BCA ASSESSMENT REPORT

PROJECT: HKH STAGE 2

HEALTH INFRASTRUCTURE

Ref.: 170370

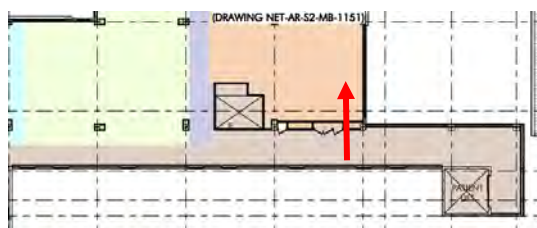
- + Level 1 – Paediatric outpatient is provided with an alternative exit from Grid EE15, across the roofed zone, back into the Paeds IPU. Note that doors are to be unlocked and openable in fire mode to ensure unencumbered paths of travel, and there is to be no steps in door thresholds.
- + Level 5 – Administration/ education floor is to be provided with fire walls and horizontal exits. In addition, future fitout planning is to introduce a corridor or door at or around the point indicated below to ensure distances to a point where a choice between alternative exits is within 20m when travelling from the Patient Lift. Notwithstanding, an allowance of up to 26m to a point of choice is considered justifiable via the **Fire Engineered Performance Solution**.

- + Level 6 plant room. Fire Walls are to be introduced to reduce extended travel distances to exits – maximum is 40m. In this instance however there is a large portion of Level 6 which is open to the sky, and results in distinctive fire separation between the enclosed parts of the plantroom. Accordingly, this open roof plant area will be considered a path of travel to alternative exits from those within each side of the plantroom, resulting in distance of up to 100m to the closest exit.

- + Level 0 – 29m to a point where a choice between alternative exits is available (service Lift Lobby).
- + Level 1 ICU, exceeds 30m to an exit (35m).
- + Level 6 plant areas results in 100m travel to the nearest exit.

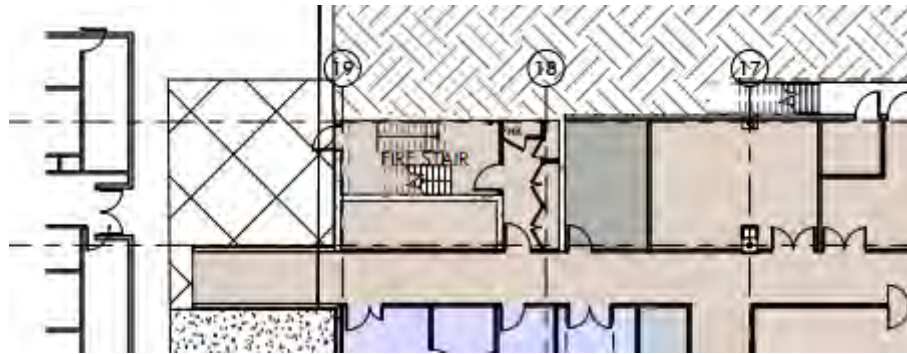
However, the corridor leading to the fire stair narrows to be less than the minimum 1.8m, in the zone that is occupied by services cupboards and the like (approximately 3m in length). In this instance a **Fire Engineered Performance Solution** will be formulated to address this departure from D1.6, and will likely suggest that the door into the corridor be deleted to enable a superior thoroughfare. .

Also, where paths of travel within plantrooms reduces to less than the required 1m in width in areas of minor encroachment by equipment and plinths that are supporting equipment, these will also be included **within the FER**.

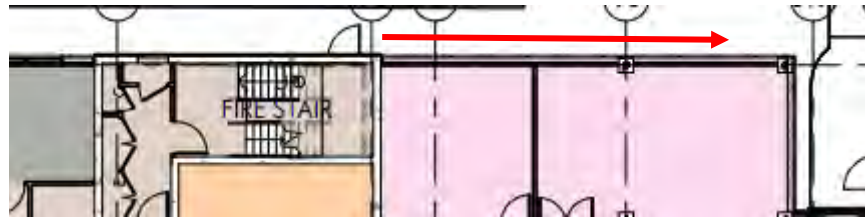
Comments: There are 2 x fire isolated exit stairs proposed for the Stage 2 development. The remainder of exits are via Horizontal Exits in fire walls, and also the design of the building utilises those existing fire isolated exit stairs within the STAR and also the HOPE building.

Discharge from Stair 1 complies with the above requirements for discharge. Its discharge remains a minimum of 6m away from this new building.

Stair 2 above. Exit door discharges into the space between the new building works and the adjoining Building 54. The wall of the new building work is to achieve an FRL of 120/120/120 for reasons of being closer than 3m to another building on the site. This will address the requirements for protection for occupants discharging from a fire isolated exit where the subject part of the building may be a risk to passing occupants.

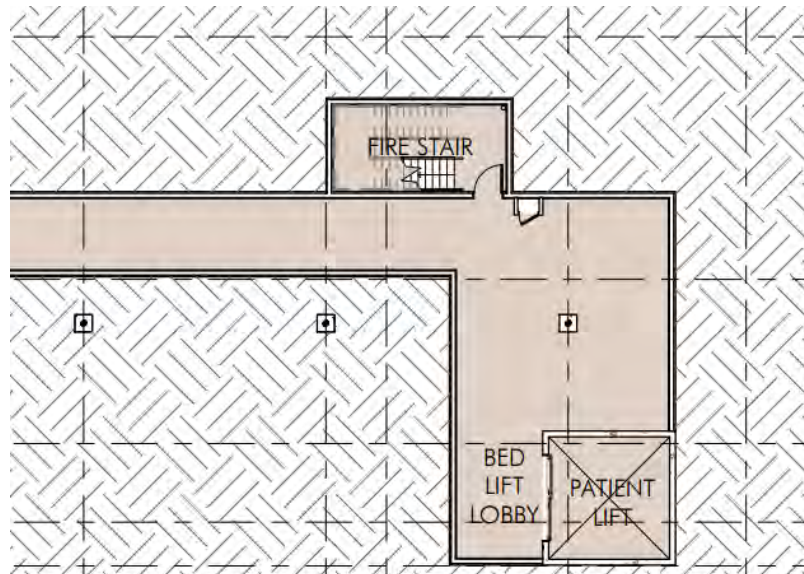
Level 0. Exit stair from Patient Lift discharges into an enclosed courtyard at Level 1 above. This discharge is subject of the **Fire Engineered Performance Solution** given that it is required to discharge back into the building at Level 1.

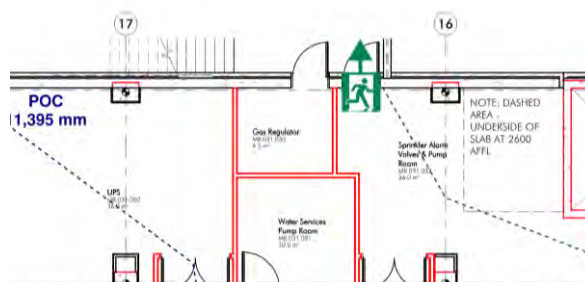
Comments: Additional information required. Details of the discharge of the stair emanating from the sprinkler valve room with respect to its path of travel to the road.

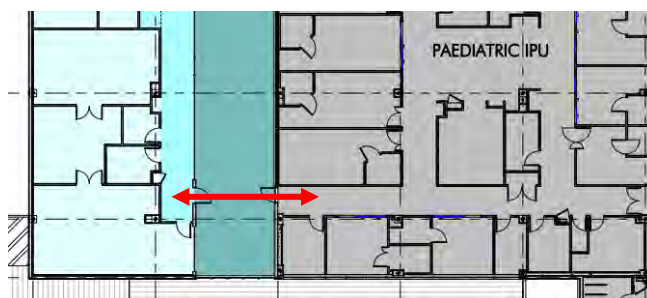
Comments: The landings in the fire isolated exits must be sufficient to move a stretcher, 2m long and 600mm wide, at a gradient not more than the gradient of stairs, with at least one end of the stretcher and the landing while changing direction between flights; or the stair must have a change of direction of 180 degrees and the landing a clear width of not less than 1.6m and a clear length of not less than 2.7m. The plans indicate that this has been achieved within the fire stairs.

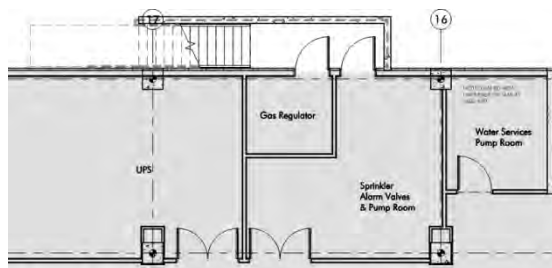
The location of the sprinkler valve is required by BCA Spec E1.5 to provide fire fighting personnel with direct egress to/from the road or open space. The location highlights that compliance is achieved.
